# PRODUCT / PROCESS CHANGE NOTIFICATION

PCN-000703

TS13102-QFNR

Assembly transfer - For Device TS13102-QFNR  
 Assembly Transfer from Carsem Suzhou to Carsem Malaysia  
 Qualification and Reliability report attached

### SEMTECH Package Outline on TS13102-QFNR CarsemSZ (Old) and CarsemIPH (New)

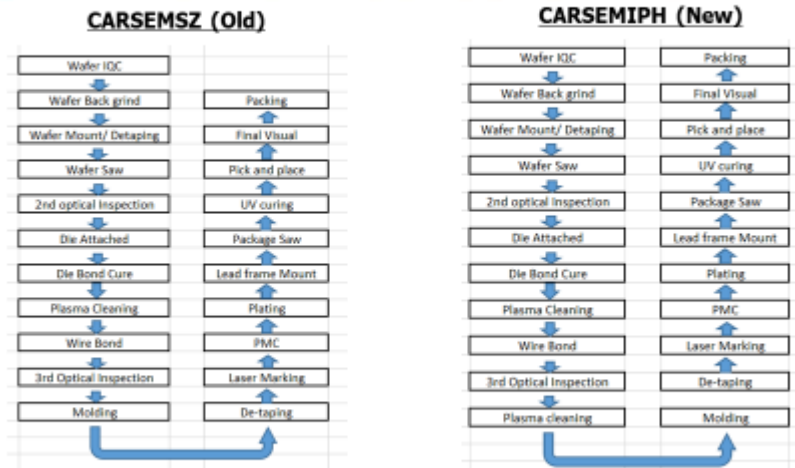
**No Change in Package Outline.**

### Assembly Process Flow Comparison for CarsemSZ (Old) vs. CarsemIPH (New)

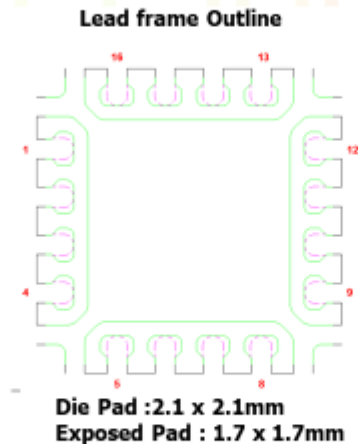
- No major Change in manufacturing Flow for both Assembly site CarsemSZ versus CarsemIPH except additional process step for plasma cleaning before mold for Carsem IPoh.

**Lead frame outline Comparison CARSEMSZ (OLD) Vs CARSEMIPH(NEW)**

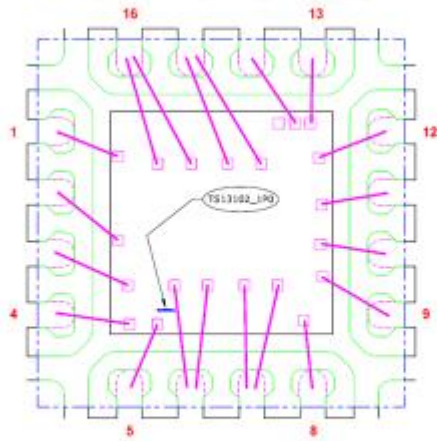
**No Difference on lead frame outline for CARSEMSZ and CARSEMIPH as both are using the same lead frame.**
